MASTER PLAN AND ZONING COMMITTEE
City of Novi Planning Commission
November 13, 2019 at 6:00 p.m.
Novi Civic Center – Council Conference Room
45175 W. Ten Mile, Novi, MI 48375
(248) 347-0475
AGENDA

Review and provide comments on the rezoning request for approximately 19 acres of property located north of Grand River Avenue, south of Eleven Mile Road and east of Town Center Drive in Section 23 from Office Service (OS-1), Office Service Commercial (OSC) and Light Industrial (I-1) to Town Center-1 (TC-1) with a Planned Rezoning Overlay.
- 6. Adjourn**

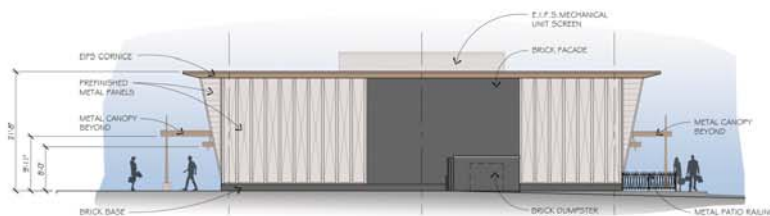
NOTE: 1. TOTAL FACADE = 1,647 S.F. - GLASS STOREFRONT AND DOOR AREA OF 335 S.F. = 1,312 S.F.
2. A SECTION 9 FACADE WAIVER WILL BE REQUESTED AS REQUIRED FOR PREFINISHED METAL PANEL COVERAGE OF 26.1% AND BRICK SHORTAGE OF 3.3 %.

WEST ELEVATION
SCALE: 3/32" = 1'-0"

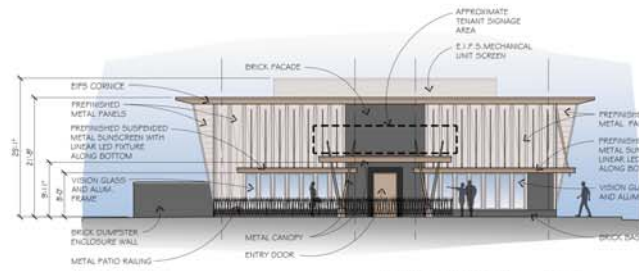
NOTE: 1. TOTAL FACADE = 1,729 S.F. - GLASS STOREFRONT AND DOOR AREA OF 0 S.F. = 1,729 S.F.
2. A SECTION 9 FACADE WAIVER WILL BE REQUESTED AS REQUIRED FOR PREFINISHED METAL PANEL COVERAGE OF 25.7 %.

Figure 1. City of Novi Regulated Wetland & Woodland Map (approximate parcel boundary shown in red). Regulated Woodland areas are shown in green and Regulated Wetland areas are shown in blue.

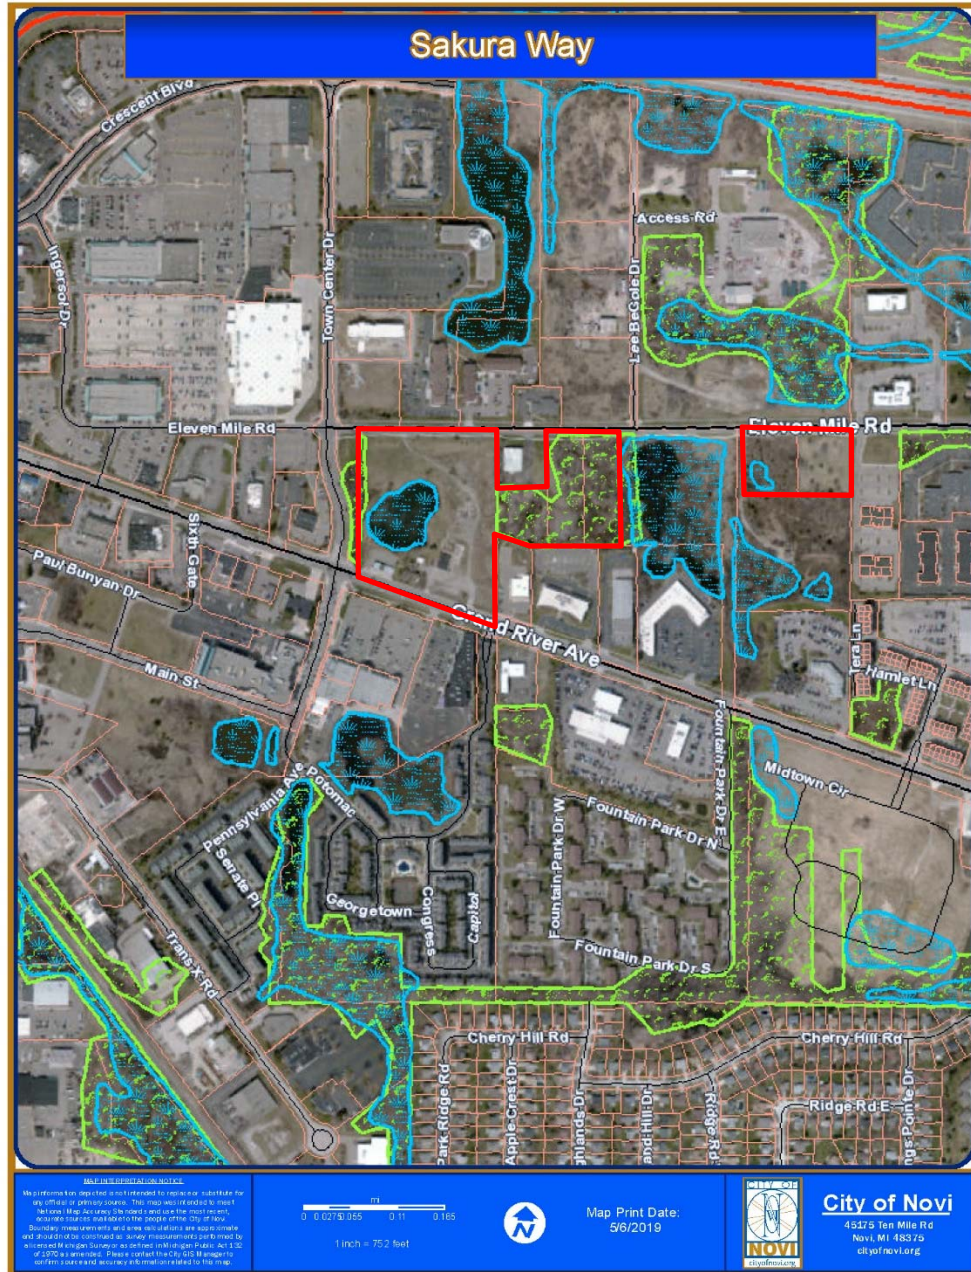
The majority of the central portion of the project site is indicated as City-Regulated Woodland on the City's Regulated Woodland Map (see Figure 1, attached). There is also area designated as Regulated Woodland along the western edge of the project property. The majority of the area that contains the open water pond/wetland (i.e. Wetland 2) is not indicated as Regulated Woodland. The parcels contained within Phase 3 of the project are also not indicated as City-Regulated Woodland. It should be noted that the purpose of the City of Novi Woodland Protection Ordinance (Chapter 37) is to:
